Contract #: 04-0120F4Cty: SF/ALA Rte: 80 PM: 13.2/13.9File #: 69.25B**QUALITY ASSURANCE -- NON-CONFORMANCE REPORT****Location:** Changxing Island, Shanghai, P.R. China**Report No:** NCR-000616**Prime Contractor:** American Bridge/Fluor Enterprises, a JV**Date:** 09-Jan-2010**Submitting Contractor:** Zhenhua Port Machinery Company, Ltd (ZPMC), Changxing Island**NCR #:** ZPMC-0589**Type of problem:**

Reference Description: Missed MT Indication by QC on 5AE/5BE Side Panel**Description of Non-Conformance:**

Subject: NCR No. ZPMC-0589

Job Name: SAS Superstructure

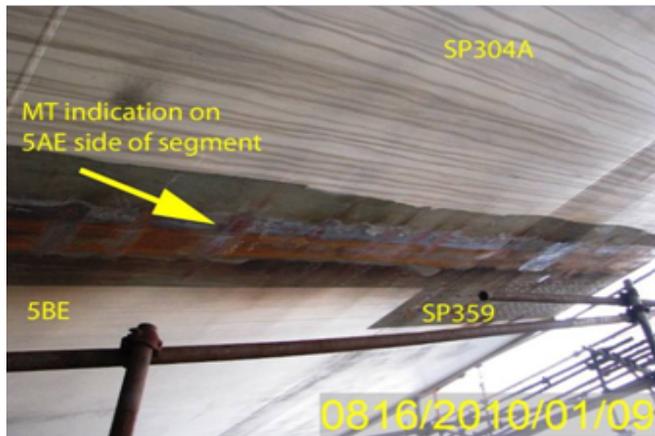
During the Quality Assurance Magnetic Particle Testing (MT) review of base metal and welds located on Segment 5AE 5BE weld splice, this Quality Assurance Inspector (QA) discovered the following issues:

- Two (2) Longitudinal linear indication measuring approximately 60mm and 30mm in length.
- The Notice of Witness Inspection Number (NWIT) is 005023. The indication is located inside the area that has been previously tested and accepted by ZPMC Quality Control (QC) personnel. According to the contract documents ZPMC Quality Control (QC) is required to perform 100% MT of temporary attachment removal areas.

- The indications were found at temporary attachment removal areas on two (2) side panels.
- The Side Panel on 5AE is identified as: SP304A
- The Side Panel on 5BE is identified as: SP359A

- Length and Y location of the MT indication on SP304A (5AE) is as followed: 60mm in length and 1800mm off corner assembly weld splice on the bike path side of segment.

- Length and Y location of the MT indication on SP359A (5BE) is as followed: 30mm in length and 5555mm off corner assembly weld splice on the bike path side of segment.

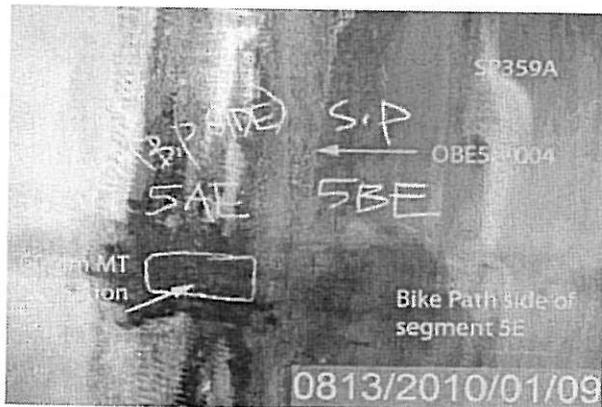
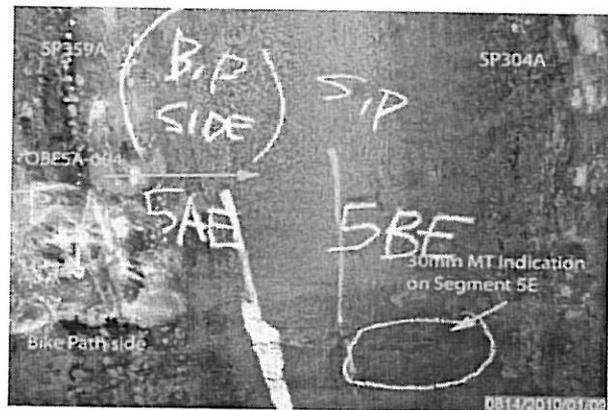
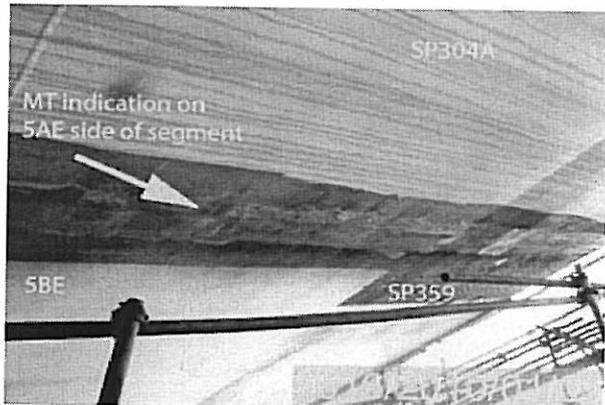
During the Quality Assurance Magnetic Particle Testing (MT) review of base metal and welds located on Segment 5AE 5BE weld splice, this Quality Assurance Inspector (QA) discovered the following issues:

- Two (2) Longitudinal linear indication measuring approximately 60mm and 30mm in length.
- The Notice of Witness Inspection Number (NWIT) is 005023. The indication is located inside the area that has been previously tested and accepted by ZPMC Quality Control (QC) personnel. According to the contract documents ZPMC Quality Control (QC) is required to perform 100% MT of temporary attachment removal areas.

- The indications were found at temporary attachment removal areas on two (2) side panels.
- The Side Panel on 5AE is identified as: SP304A
- The Side Panel on 5BE is identified as: SP359A

- Length and Y location of the MT indication on SP304A (5AE) is as followed: 60mm in length and 1800mm off corner assembly weld splice on the bike path side of segment.

- Length and Y location of the MT indication on SP359A (5BE) is as followed: 30mm in length and 5555mm off corner assembly weld splice on the bike path side of segment.

- The CJP splice weld # is designated as OBE5A-004.

项目名称 Project Name:	美国海湾大桥 SFOBB	部件图号 Drawing No.:	5AE/5BE	报告编号 Report No.:	B-CWR1174
合同号 Contract No.:	04-0120F4	部件名称 Item Name:	Temporary attachment	NDT 报告编号 NDT Report No.:	B787-MT-18541
项目编号 Project No.:	ZP06-787

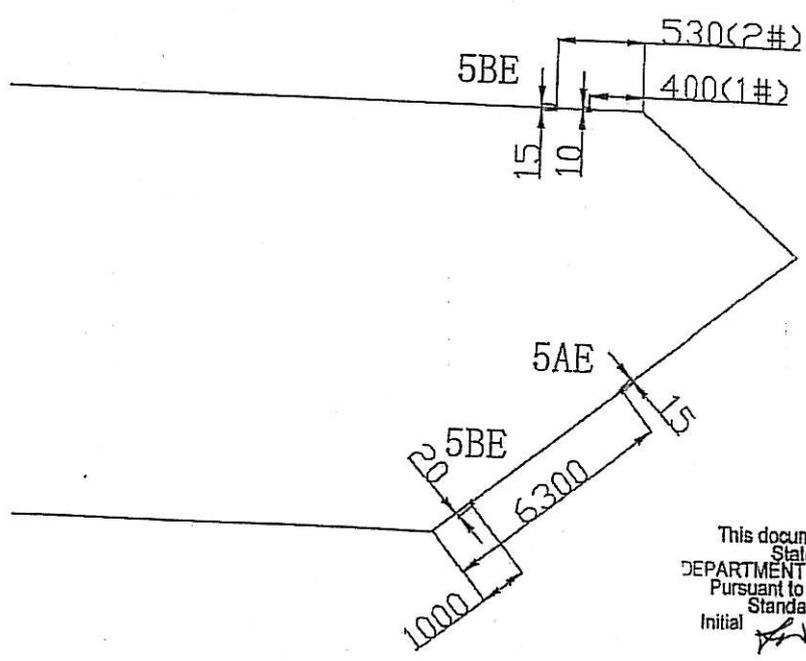
在对SP304A检测时, 发现1处横向裂纹。1、L=15mm
 在对SP305A检测时, 发现1处横向裂纹。1、L=20mm
 在对DP633A检测时, 发现2处横向裂纹。1、L=10mm;2、L=15mm
 Welder ID No. (焊工编号):048659 Position:(位置): 1G
 One transverse crack was found by use of MT on SP304A. ✓
 One transverse crack was found by use of MT on SP305A.
 Two transverse cracks were found by use of MT on DP633A.

1. 火焰加热时, 水汽没有完全的去掉或者这个区域预热不够;
1. Moisture wasn't completely removed during drying operation (preheating) or the area wasn't preheated sufficiently.

1. QC and a Lead CWI shall be present, direct and supervise all grinding and welding operations during this repair to ensure the repair is per the disposition requirements

2. QC and a Lead CWI shall have an approved copy of the CWR in hand prior to the repair.
3. Remove paint ≥ 25 mm in all direction of HAZ prior to MT.
4. Extend repair .50mm beyond each end of the crack and 50mm beyond the outermost cracks for multiple crack repairs.

5. Clean the excavation area of all loose debris including MT powder. Remove defects by grinding. Preheat to 65° C before removing cracks by grinding;
6. Perform base metal repair work prior to performing joint repair work when crack removal procedures result in damage than 3mm,

7. Prepare excavation in accordance with the New Repair Procedure prior to welding.
8. Perform VT and MT prior to welding to verify no defects exist;
9. Clean excavation area of all loose debris including MT powder after excavation. Preheat and weld according to repair WPS, the minimum preheat shall not less than 160° C—230° C;

10. Perform post weld heating according to repair WPS, the postheat shall between 230° C—315° C and for one hour minimum.
11. Allow the weld to cool to ambient temperature gradually. Control cooling rate after PWHT to no more than 50° C per hour

12. Grind the repair area flush with base metal or the adjacent weld;
13. Wait 48 hours at least after the repair area has cooled to ambient temperature before performing NDT.

14. Perform VT, MT and UT on repair area to ensure no defects exist.

Item No: PL912A

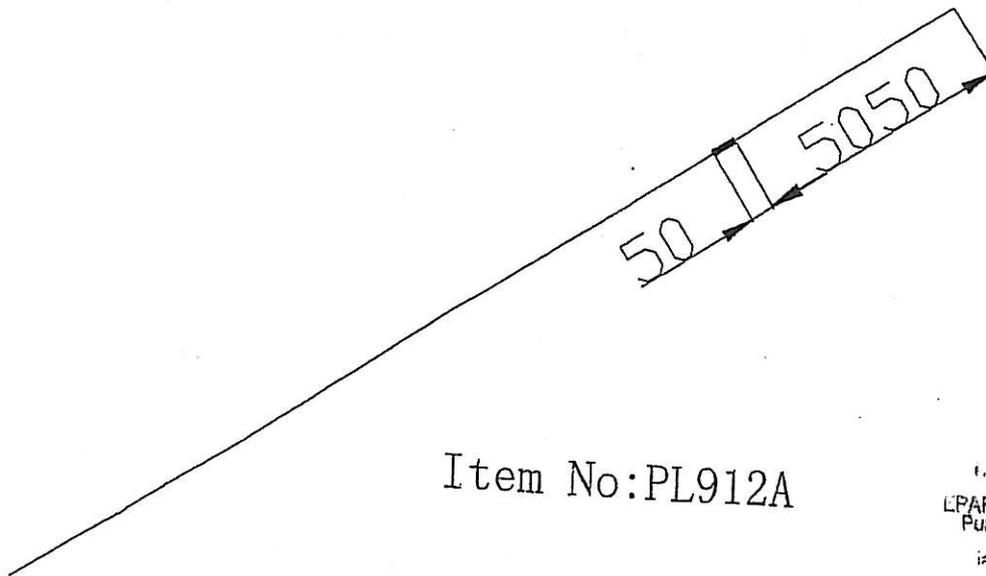
One longitudinal crack was found by use of MT on base metal PL912A.

1. 火焰加热时, 水汽没有完全的去掉或者这个区域预热不够;
1. Moisture wasn't completely removed during drying operation (preheating) or the area wasn't preheated sufficiently.

1. QC and a Lead CWI shall be present, direct and supervise all grinding and welding operations during this repair to ensure the repair is per the disposition requirements

2. QC and a Lead CWI shall have an approved copy of the CWR in hand prior to the repair.
3. Remove paint $\geq 25\text{mm}$ in all direction of HAZ prior to MT.

4. Clean the excavation area of all loose debris including MT powder. Preheat to 65° C before removing cracks by grinding, repair area shall extend a minimum of 50mm beyond each end of single crack repairs.

5. If base metal is damaged by grinding, the damaged area shall be ground clean prior to performing weld repair. If gap $> 5\text{mm}$ is found during or after grinding, comply with the notification on changing fillet weld to CJP which is submitted for Engineer's review and approval form.

6. Prepare excavation in accordance with the New Repair Procedure prior to welding.
7. Before this repair, Verify with VT and MT repair areas are defects free, and also MT shall be performed on the base metal laying abroad cracks to ensure that no cracks were propagated to the base metal. Separate CWR approval is needed if cracks are found in the base metal, and only after this new CWR's approval can continue the repair.

8. Clean excavation area of all loose debris including MT powder after excavation. Preheat and weld according to repair WPS, the preheat shall between 160° C-230° C.

9. Perform post weld heating according to repair WPS, the postheat shall between 230° C-315° C and for one hour minimum.
10. Allow the weld to cool to ambient temperature gradually. Control cooling rate after PWHT to no more than 50° C per hour.

11. Grind the repaired area flush with base metal or the adjacent weld after post weld heating.
12. Wait 48 hours at least after the repair area has cooled to ambient temperature before performing NDT.

13. Perform MT inspection to all repair area according to Contract Drawings along with all additional NDT required by the applicable notes Special Provision Section 10-1.59 'Steel Structure', subsection 'inspection and testing'. NDT include VT, MT and UT if it is a CJP weld.
